Summary of the UT Conceptual Review Report & responses by the group

Marina Artuso for the UT working group

- ❑ UT Conceptual design review took place on November 14–15, 2013
- ❑ Referees: M. Newcomer (University of Pennsylvania), T. Affolder (U. Liverpool), D. Lynn (Brookhaven), from LHCb K. Wyllie and F. Alessio (CERN).
- ❑ Web site <https://indico.cern.ch/conferenceDisplay.py?confId=272144>

the stave

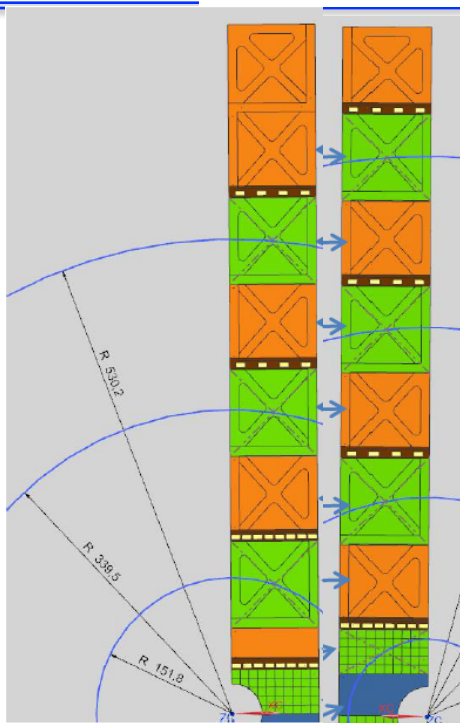
- ❑ The stave design follows developments from ATLAS and **in principle should work** with a couple of caveats. **The snake pipe design may have problems with extra pressure drops or internal pressure forcing the pipe to straighten.** We recommend also modeling a straight pipe design similar to what was presented but with the carbon foam optimally placed for maximum cooling. Also, if the pipe and cooling with the snake pipe does work, it is worth considering a mirror image design in which the pipe enters from the other edge of the stave so that the pipe more closely approaches the beam pipe cutout region in the middle of the stave. The team should focus on quickly resolving the pipe design as this impacts the stave construction.

- Determination of the cooling tube design (snake vs straight) is our top priority and is ongoing now. Both prototyping of real material demonstrator modules and the related thermal simulations are being pursued to settle this issue. These will be more advanced than the results previously shown. We expect to have a resolution in Q1 2014 .

the hybrid “hitech” problem

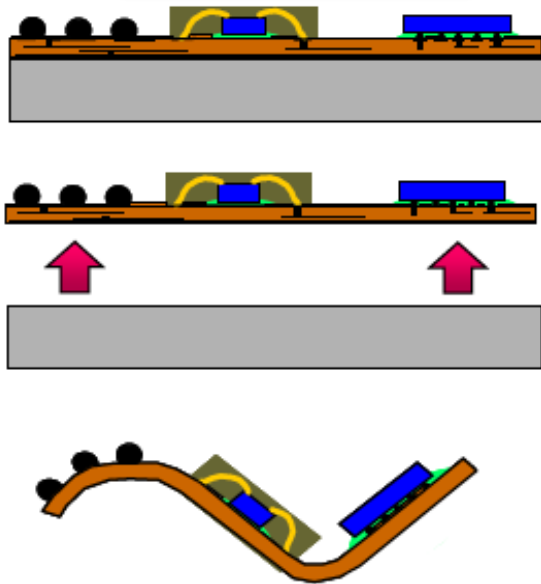
□ “a hi-tech hybrid technology was presented motivated by the goal of implementing the data transmission in the most compact form & using the same technology for hybrids and cables

□ problems:

- Expensive
- Sensor-ASIC alignment issues for hybrids

once the rigid substrate is detached, hybrid is very flexible and is not suitable for precision wirebonding to the Si hybrid

conventional hybrid-flex (adapted from ATLAS/ CMS trackers), see talk by S. Blusk, <https://indico.cern.ch/getFile.py/access?contribId=8&resId=0&materialId=slides&confId=272144>

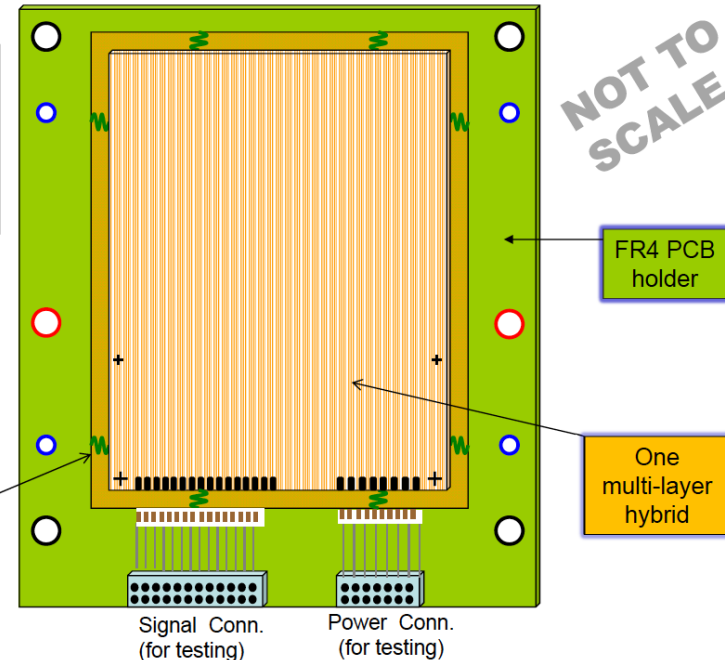
“hinge-like” structures to minimize mechanical stress on hybrid

now we agree that this will be our baseline solution
